**STAFF REPORT**  
**(One-Step Final Plat)**

**CASE NUMBER:** SUB 2004-86 -- THE WATERFRONT FIFTH ADDITION

**LOCATION:** North side of 13th St. North, East of Webb Road

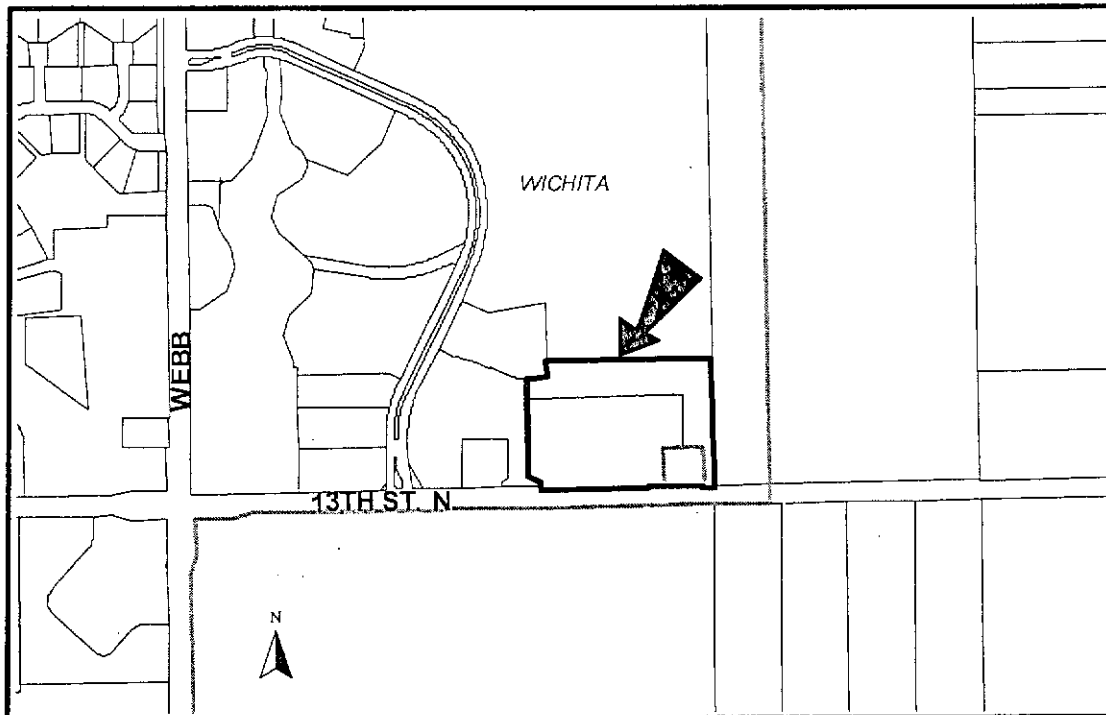
- J. The Applicant is advised that if platted, the building setbacks may be reduced to 20 feet.
- K. The legal description does not match the plat boundary.

- L. The dimension on the east line of Lot 2 needs to be corrected.
- M. The Applicant is reminded that a platting binder is required with the final plat. Approval of this plat will be subject to submittal of this binder and any relevant conditions found by such a review.
